Ref: FSU Education Building – Nursing Simulation

Subj.: **ADDENDUM BULLETIN NO. 4**

1 NURSING LABRATORY ENTRANCE ELEVATION

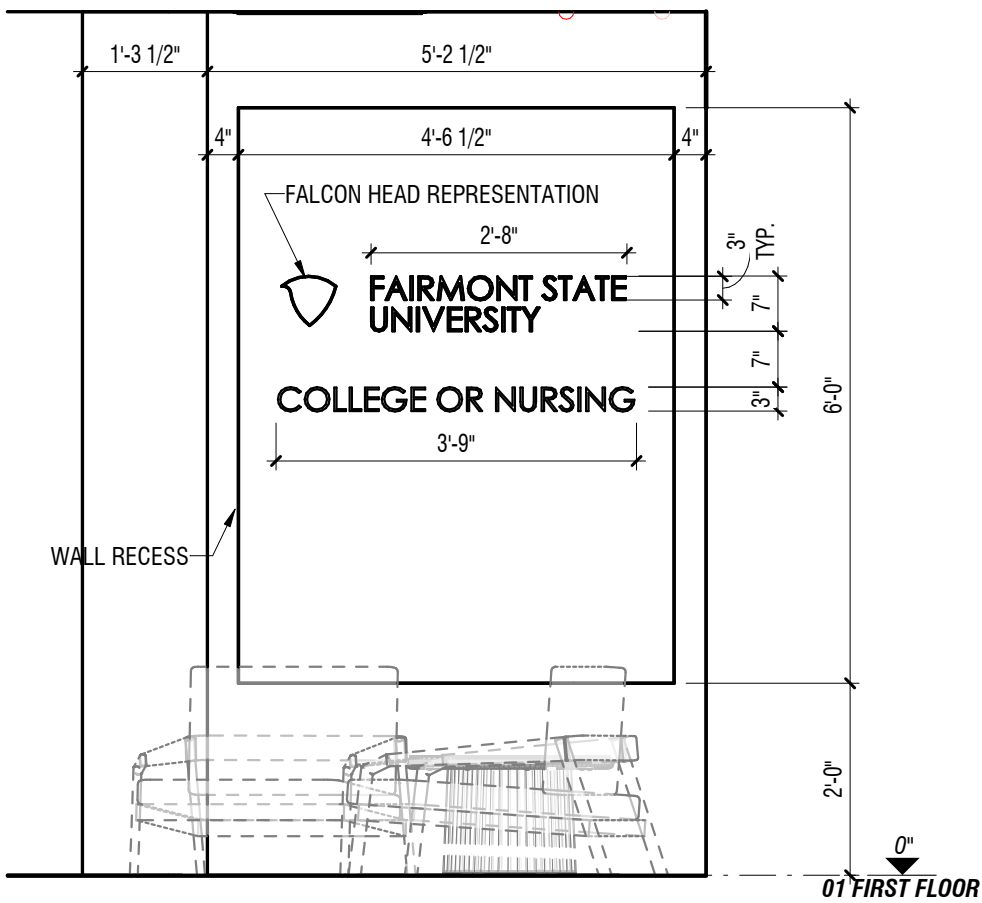
Addendum 4 – Item 5 Signage: FOR CLARIFICATION, Detail 1/A-4.14 states existing signage to be relocated is this one sign or individual letters? Are these on an accent panel? – **One sign. See attached SK02.**

2 NURSING LABRATORY ENTRANCE SIDE ELEVATION

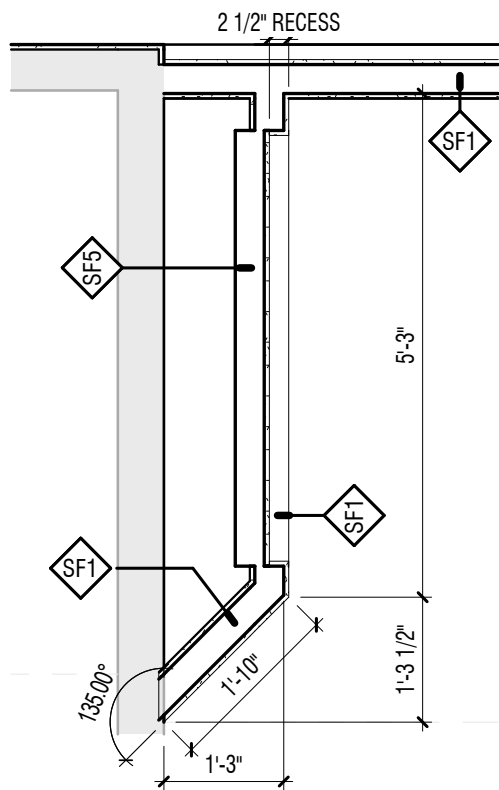
Addendum 4 – Item 4 Signage: FOR CLARIFICATION, Reference 2/A4.14: is the lettering painted or dimensional? If dimensional, please provide material/font/finish/mounting, etc. Also, is the tinted background part of the signage or is it wall surface? – **Dimensional standoff lettering. Font & color to be selected by CMCS during submittal review. See attached drawing A-4.14 for dimensions. Dywall wall surface behind.**
